Glanmire Solar Farm – Request for Information

I refer to the State significant development application for the Glanmire Solar Farm (SSD 21208499) (**Application**), currently before the Independent Planning Commission (**Commission**) for determination.

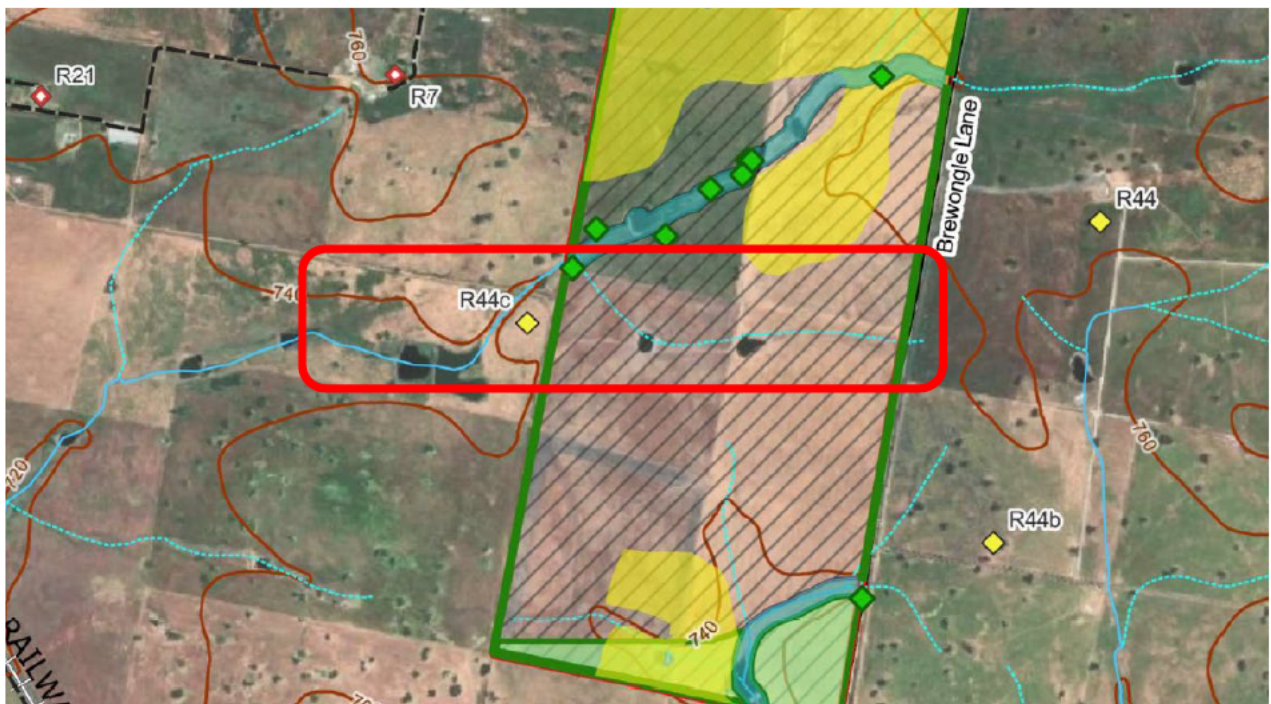
2. Please confirm the precise extent of the proposed setbacks on the eastern and western boundaries of the development site, including the extent within these setbacks that is proposed for vegetation screenings, asset protection zones, maintenance tracks, and existing roads.
3. Please confirm whether the western setback relies on adjoining land to provide an appropriate buffer.
4. Please confirm the rationale for the proposed exclusion zone at the northern end of the site (south of the 300m setback to Great Western Highway).
5. Please confirm the dimensions of the proposed southern setback.

9. The Commission heard concerns at the Site Inspection, Locality Tour and Public Meeting regarding water storage, flow changes and potential flooding impacts, both on site and to neighbouring properties. Noting this, please advise how the first order stream flowing into R21 and shown in the 'General layout showing Development footprint and constraints' plan (Appendix A.1 of the Amendment Report – see marked up screenshot below) was considered during the Application's design and the final proposed solar PV array layout.
